**City Planning Commission  
Planning Meeting – January 27, 2015**

**CONSIDERATION – SUBDIVISION DOCKET 181/14  
Applicant: USB Capital, LLC**

**Prepared By:** Stephen Kroll  
**Date:** January 16, 2015  
**Deadline:** February 9, 2015

**Proposal:** Resubdivision of Lots 8, 9, 10, and Pt. 11 into proposed Lots 8A and 10A.

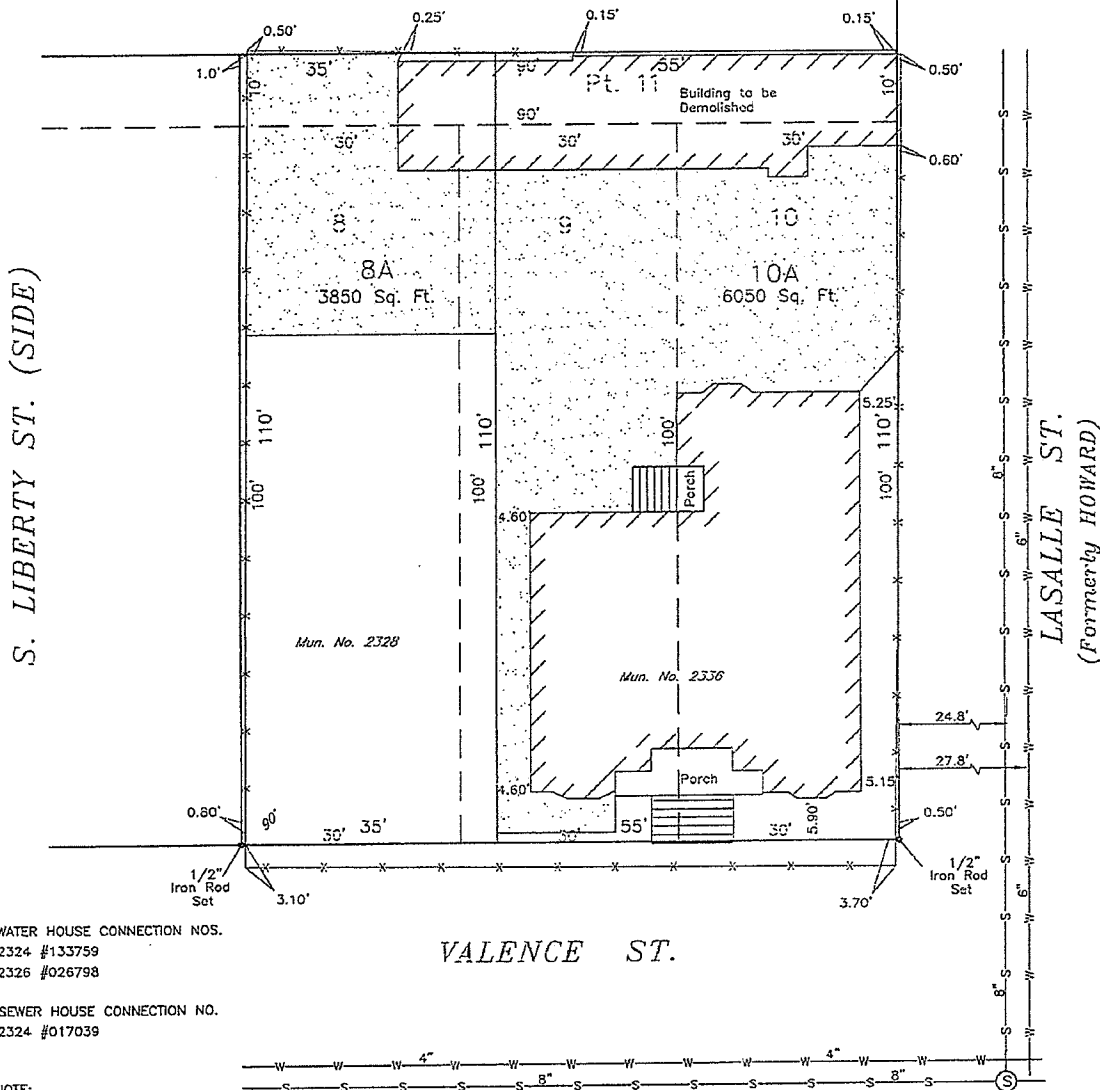
The Sewerage and Water Board stated that sewer and water facilities and subsurface drainage are available for the proposed lots. It also noted that sewer and water house connections are available but not shown on the resubdivision survey and so a note should be shown on the survey indicating that sewer and water house connections are the responsibility of the property owner.

(It should be noted that the existing lots shown on the survey do not match the lots shown on the City's zoning map. Instead of showing the site as including three lots facing Valence Street and a fourth lot facing La Salle Street, the City's zoning map shows the site as including two lots, Lots 24 and 25, which each measure 45 feet in width, 110 feet in depth, and 4,950 square feet in area.)

Additionally, the proposal would cause the residence at 2336 Valence Street to have an aggregate side yard (i.e., the combined width of the two individual side yards) of 9.75 feet, which is 17.7% of the 55 foot width of proposed Lot 10A. This is in contrast with the existing condition, where the structure has an aggregate side yard of 44.75 feet, which is 49.7% of the 90 foot width of the existing development site. In accordance with **Article 4, Section 4.5.7** and **Table 4.E** of the Comprehensive Zoning Ordinance,

residences in the RD-2 District are required to have an aggregate side yard that is 20% of the lot's width (with a maximum requirement of 12 feet). Since the subdivision proposal would cause the residence's aggregate side yard to become substandard of this requirement, the applicant must either alter the subdivision proposal to eliminate this substandard condition (by shifting the proposed common lot line between Lots 8A and 10A toward South Liberty Street by approximately two feet) or by obtaining a variance of the minimum aggregate side yard requirement from the Board of Zoning Adjustments. The Board would have to evaluate whether such a variance would be justifiable under its standards for variance in **Article 14, Section 14.6.4** of the Comprehensive Zoning Ordinance, so it is not guaranteed that it would grant the variance.

1. The applicant shall apply for and obtain variances from the Board of Zoning Adjustments of the minimum lot width and minimum lot area requirements contained in **Article 4, Section 4.5.7** and **Table 4.E** of the Comprehensive Zoning Ordinance for proposed Lot 8A.

2. The applicant shall ensure that the residence at 2336 Valence Street on proposed Lot 10A complies with the applicable aggregate side yard requirement, either by altering the resubdivision proposal to bring it into compliance with the aggregate side yard requirement in **Article 4, Section 4.5.7** and **Table 4.E** of the Comprehensive Zoning Ordinance or by applying for and obtaining a variance of the requirement from the Board of Zoning Adjustments.
